ASSIGNMENT: Extension of Tram Track between Ilidža and Hrasnica

SUBJECT: Clarifications and answers on the received questions and Amendment of the Tender Documents _ third

SUBJECT: Clarifications and answers on the received questions and Amendment of the Tender Documents _ first

SUBJECT: Clarifications and answers on the received questions and Amendment of the Tender Documents _ second

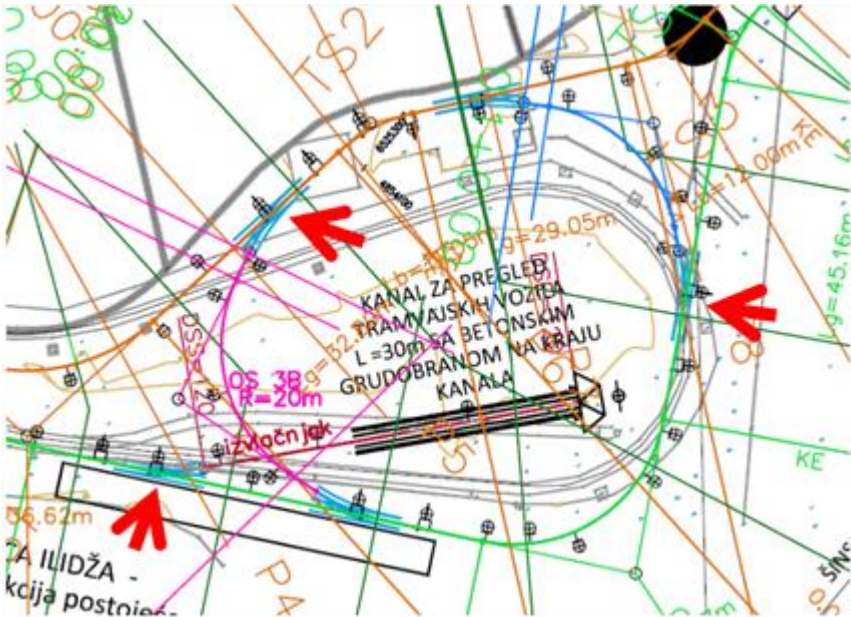
In the G-phase (item 39) question is are the switches trailable? Also, the bidder needs clarification on what the left and right switches mean (in electrical rather than construction terms).

Yes, the switches are trailable.

There are 3 electric switches and two mechanical switches in the Ilidža turnpike, and one electric and one mechanical switch in the Hrasnica turnpike. See figure below (red arrow-electric switches, others are mechanical). The electric switch is redirected via the tram control, i.e. electrically. "Left" means that the redirection is done only to the left, it means that it has only the position "right

(straight)" and "left". Mechanical switches are exit switches and have no electrical equipment, they are located at the exits and the tram "switches" them while passing through them.
